Re: 06V-258, 06V-259, 06V-279

Bulletin Number: V-06-03

### SUBJECT: Fuel pump retainer clip failure

## SPECIAL INSTRUCTIONS FOR FUEL PUMP REPLACEMENT:

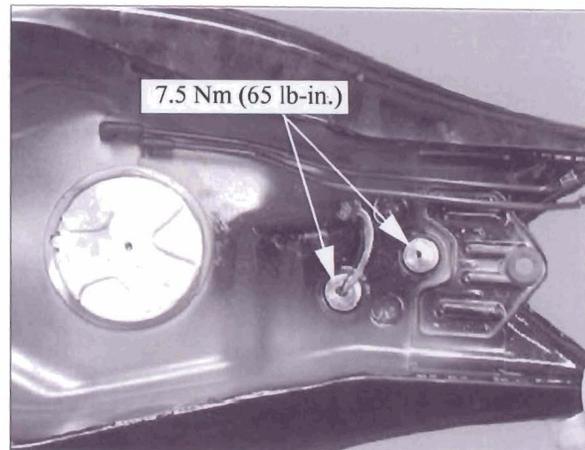
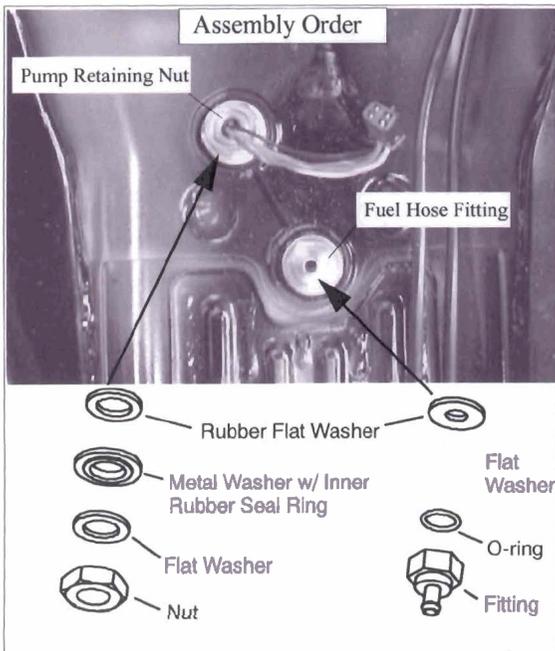
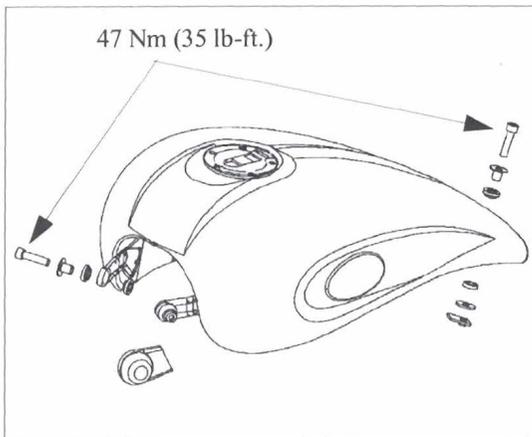
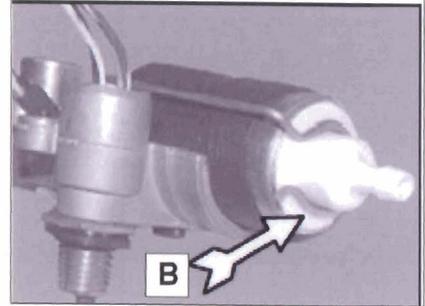
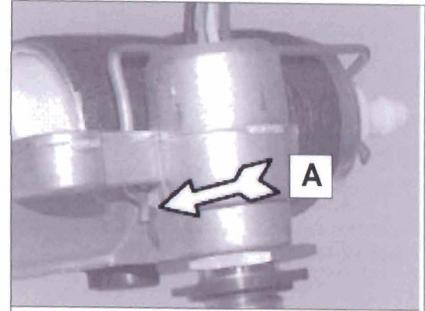
The fuel pump retainer clip may have been weakened by a tooling mark, which may allow the fuel pump inlet port to separate from the fuel pump body, causing a reduction of fuel pressure at the fuel rail. Reduced fuel pressure can cause poor performance or possible engine stalling, increasing the risk of a crash.

3. It is difficult to see the difference between the original retaining clip and the new clip. To prevent confusion during assembly, mark the original clip with a permanent marker prior to removing it.

4. Remove the clip and install the new one from the kit.
5. Be sure clip is properly seated in the pump body (A) and around the fuel inlet nozzle (B).
6. Install fuel pump in fuel tank as outlined in the appropriate Service Manual.

7. Torque pump retaining nut and fuel hose fitting to 7.5 Nm (65 lb.-in.).
8. Torque fuel line, vent line, and water drain line hose clamps to 2.5 Nm (20 lb.-in.).

9. Torque vent and drain hose clamps to 2.5 Nm (20 lb.-in.).
10. Install fuel tank. Torque mounting bolts to 47 Nm (35 lb.-ft.).
11. Prime the fuel pump as outlined in the Service Manual.
